**NEW YORK STATE THRUWAY AUTHORITY
DEPARTMENT OF ENGINEERING**

**AMENDMENT NO. 1
TO**

**CONTRACT TAB 25-13
D215028
PAVEMENT REHABILITATION, SAFETY IMPROVEMENTS
AND MISCELLANEOUS WORK ON I-90
FROM MILEPOST 419.4 TO 425.9
IN THE BUFFALO DIVISION
OF THE NEW YORK STATE THRUWAY
IN ERIE COUNTY**

**IN THE LETTING OF
NOVEMBER 19, 2025**

TITLE OF PROJECT I-90 EB AND WB PAVEMENT REHABILITATION	CONTRACT NUMBER: TAB 25-13
LOCATION OF PROJECT MP 419.4 - 425.9	DATE: JULY 2025
TITLE OF DRAWING MISCELLANEOUS DETAILS 3 OF 8	DRAWING NUMBER: MSD-3

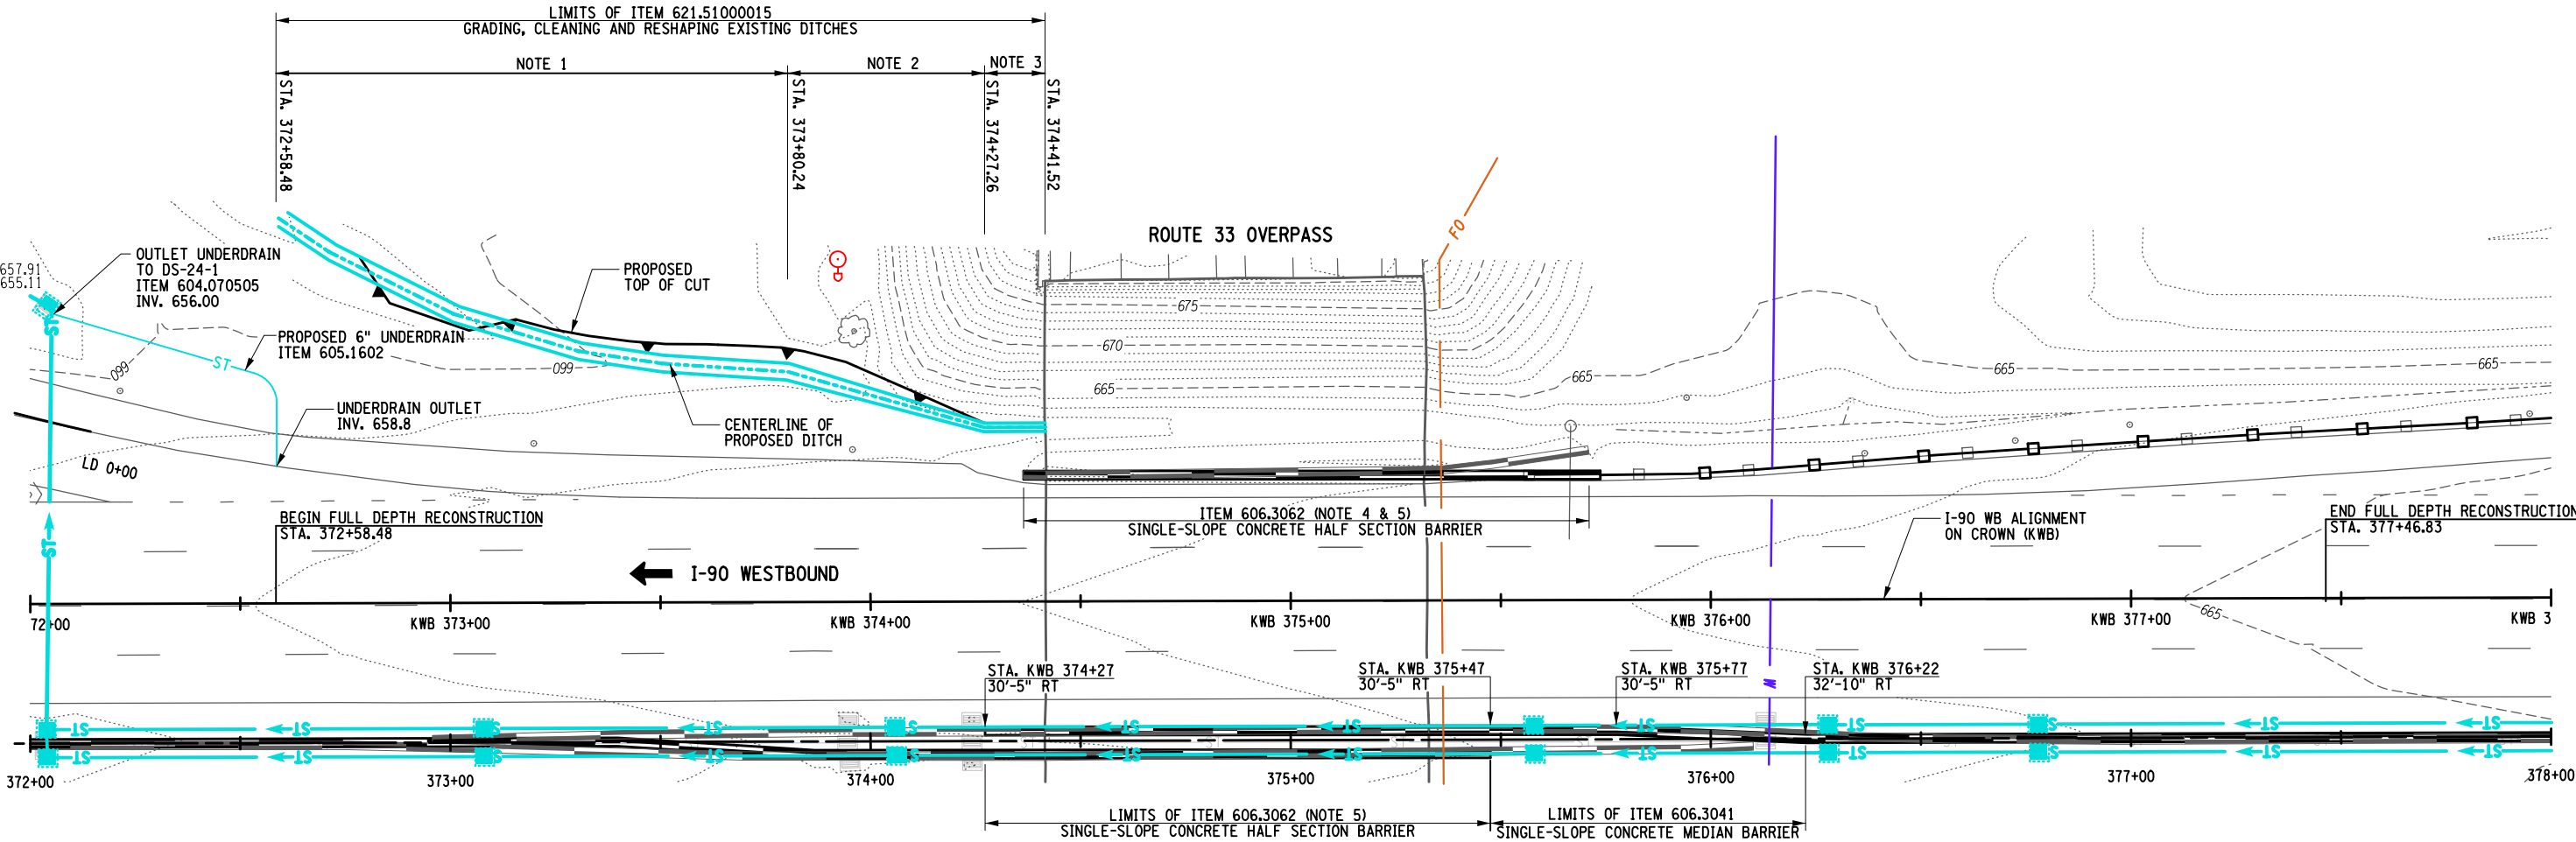
18. **DELETE** Drawing Number MSD-3, Sheet 145 of 371, and **SUBSTITUTE** with the attached Drawing Number MSD-3, Sheet 145-A1 of 371. In the “Overpass Median Barrier Transition Detail” reference to Item 606.3042 was changed to Item 606.3041, instead. In addition, previous reference to Item 555.0105 has been removed and Item 555.0021 and Item 559.02 were added to the “Median Barrier Sign Structures Detail”.

CONTRACT NUMBER:
TAB 25-13
DATE:
JULY 2025
DRAWING NUMBER:
SPK-2

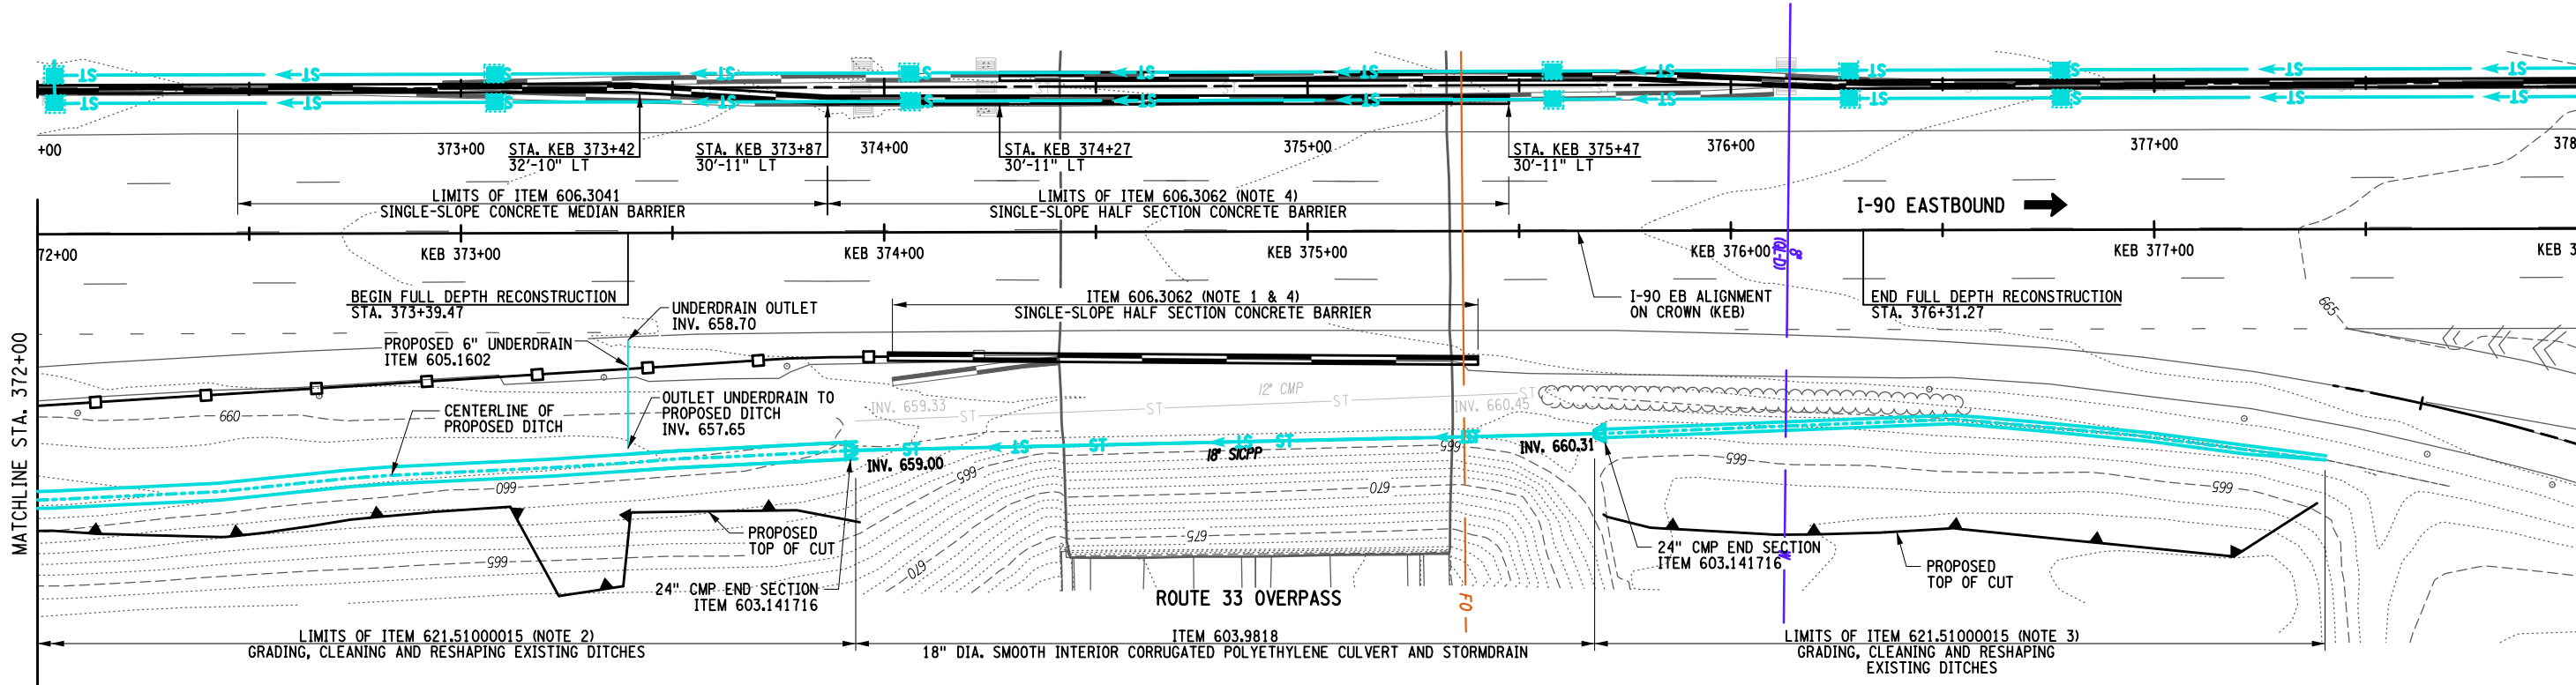
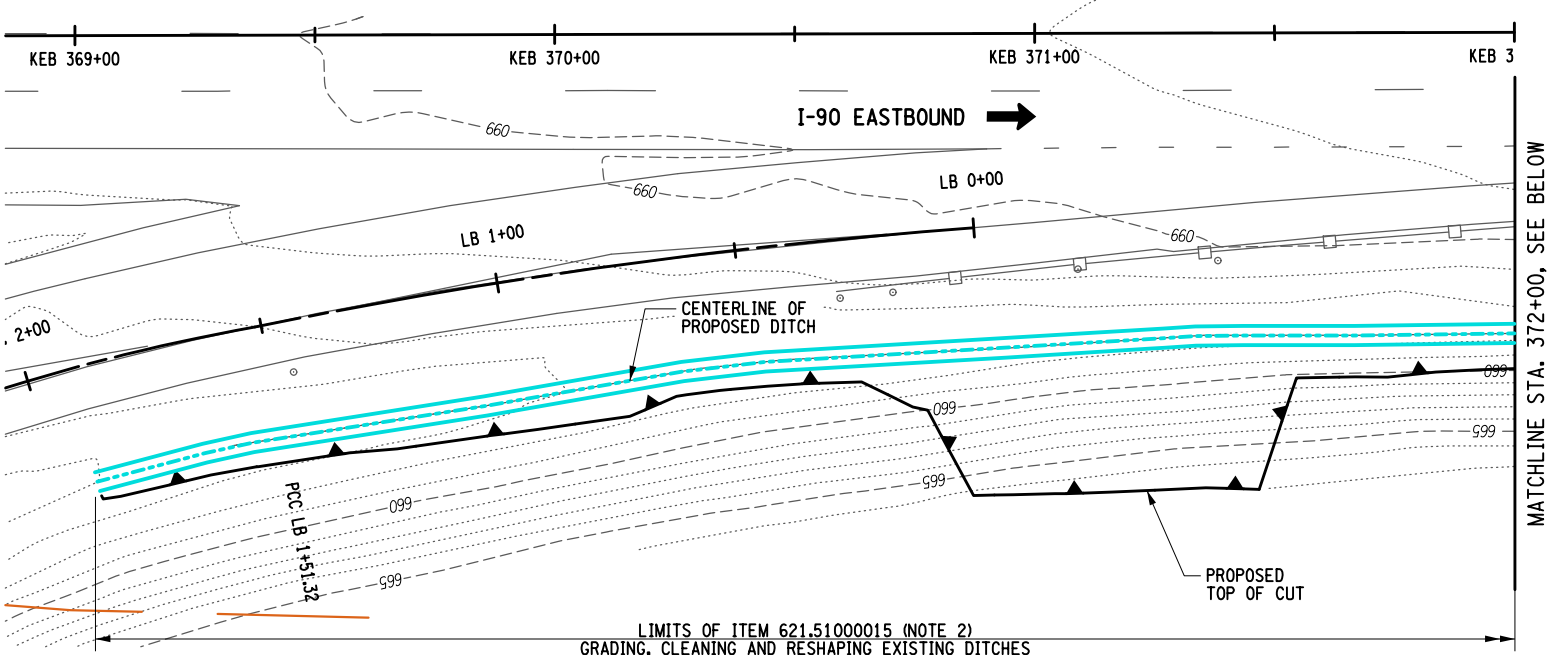
20. **DELETE** Drawing Number SPK-2, Sheet 154 of 371, and **SUBSTITUTE** with the attached Drawing Number SPK-2, Sheet 154-A1 of 371. Item 606.3042 was changed to Item 606.3041 and a callout (to Item 606.3062) was updated to (also) reference existing Note 4.

M M MOTT MACDONALD	TITLE OF PROJECT I-90 EB AND WB PAVEMENT REHABILITATION	CONTRACT NUMBER: TAB 25-13
	LOCATION OF PROJECT MP 419.4 - 425.9	DATE: JULY 2025
	TITLE OF DRAWING GENERAL PLAN	DRAWING NUMBER: GNP-33

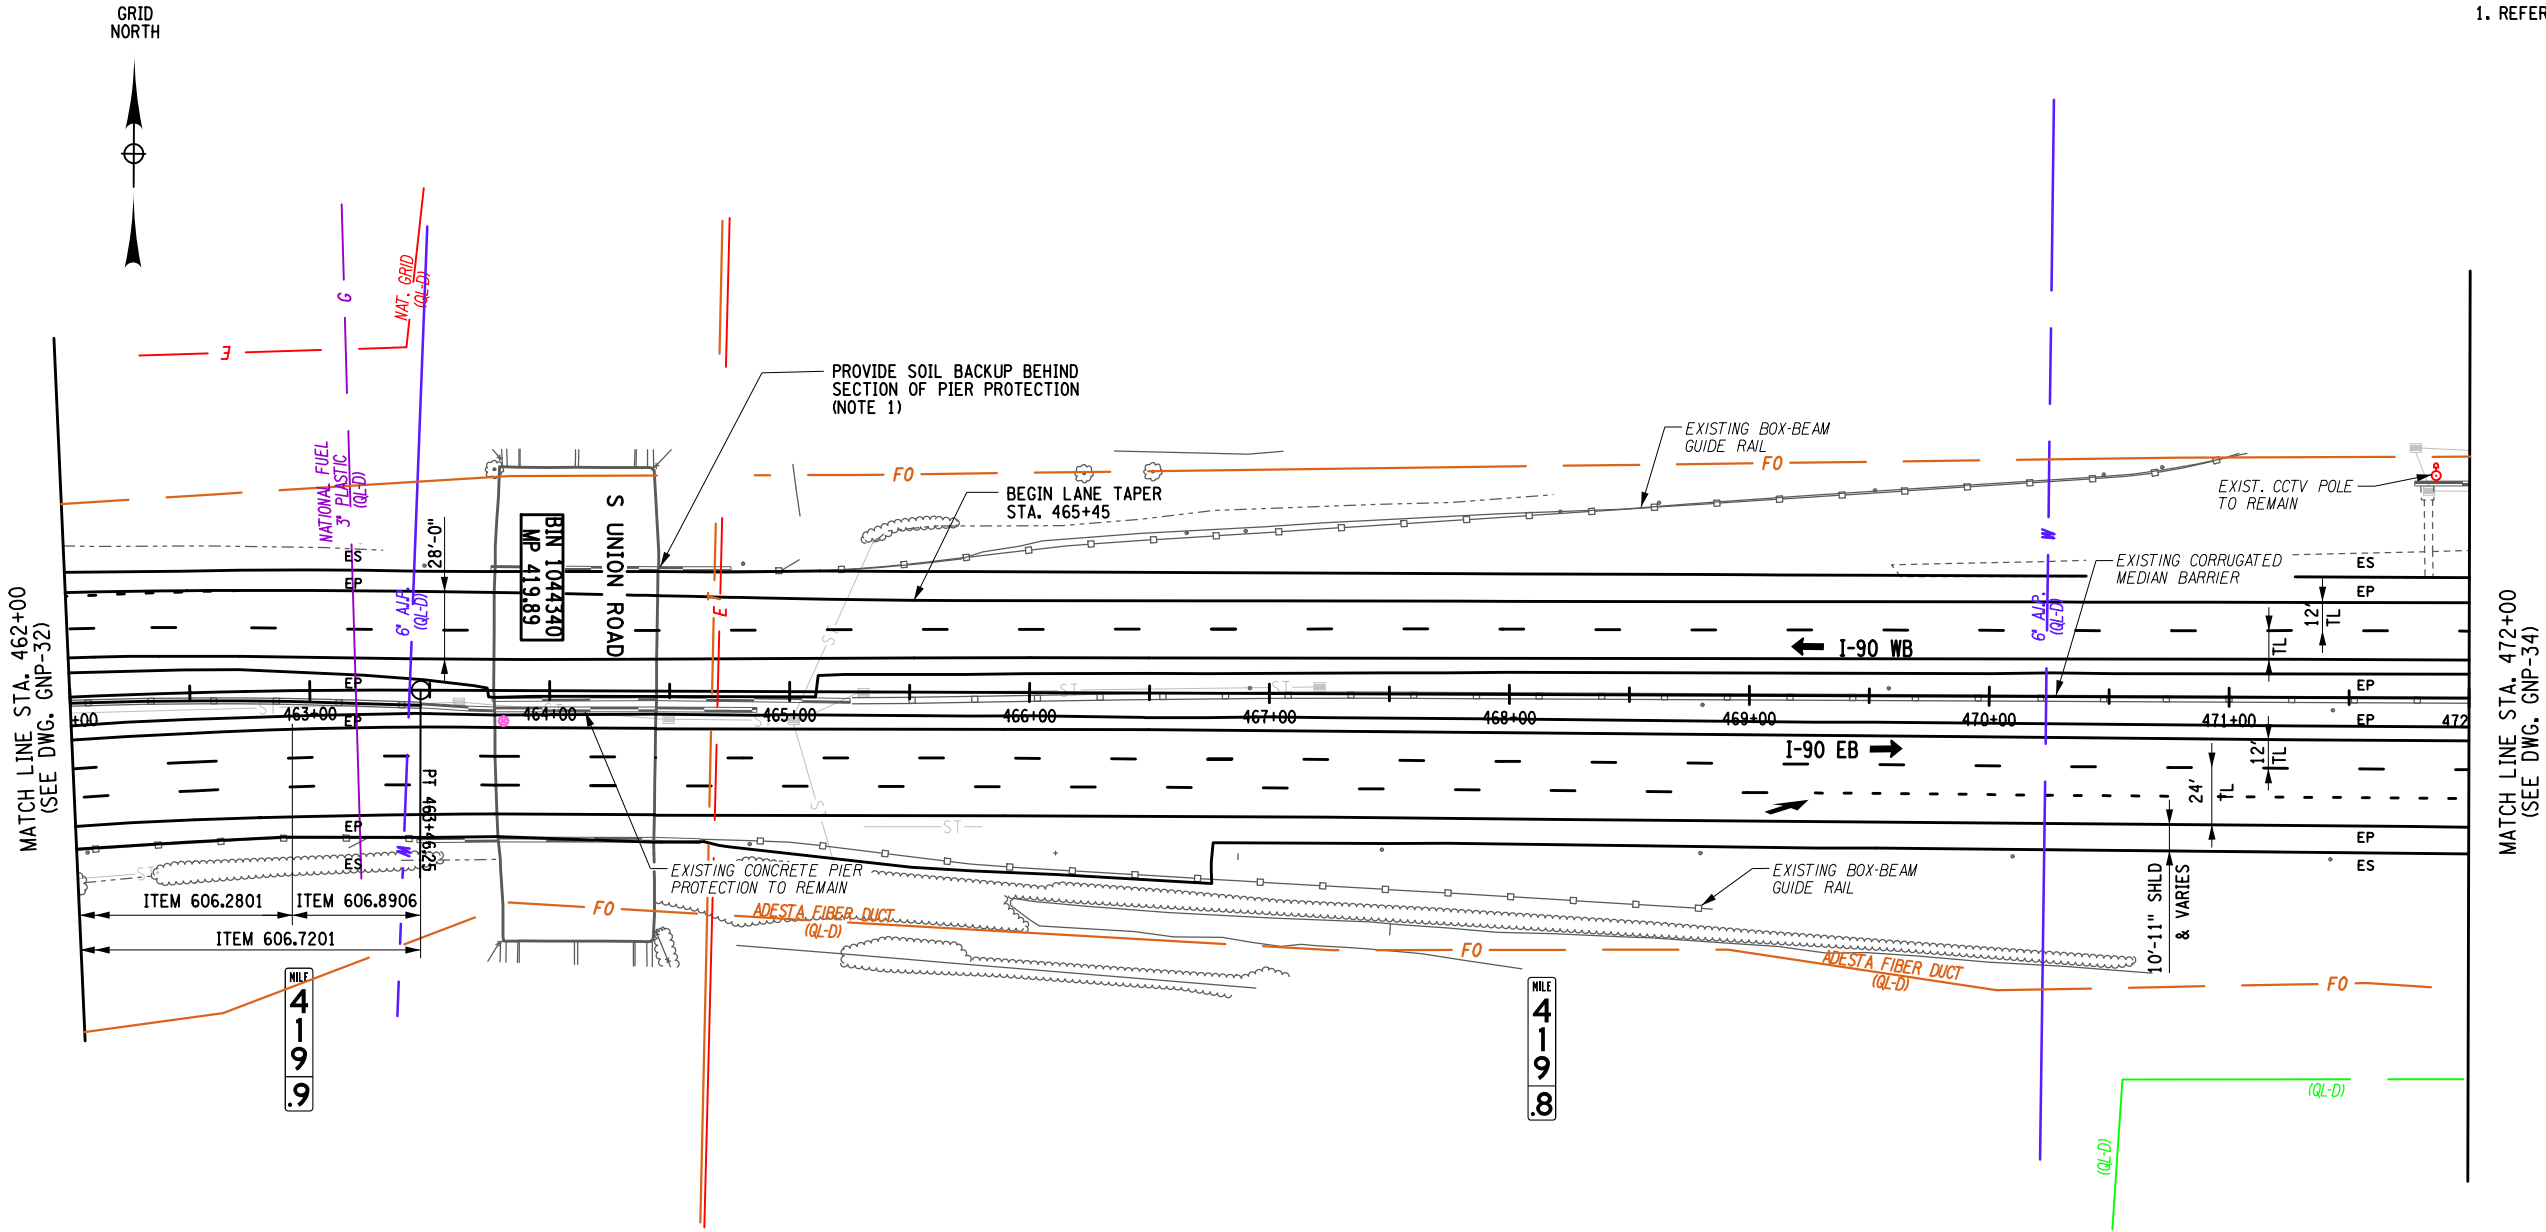
21. **DELETE** Drawing Number GNP-33, Sheet 189 of 371, and **SUBSTITUTE** with the attached Drawing Number GNP-33, Sheet 189-A1 of 371. A Note was added to reference Drawing Number MSD-2 regarding the soil backup requirement at the pier protection.
22. **DELETE** Drawing Number DND-1, Sheet 329 of 371, and **SUBSTITUTE** with the attached Drawing Number DND-1, Sheet 329-A1 of 371. The call out to Item 606.3042 in the “Proposed Drainage System” Detail was corrected to Item 606.3041, instead.
23. **DELETE** Drawing Number DNP-24, Sheet 358 of 371, and **SUBSTITUTE** with the attached Drawing Number DNP-24, Sheet 358-A1 of 371. A new Note 5 now referring to Drawing Number TYP-18 and the “Typical Section S” Detail was added regarding the installation of the 24” R.C.C.P.
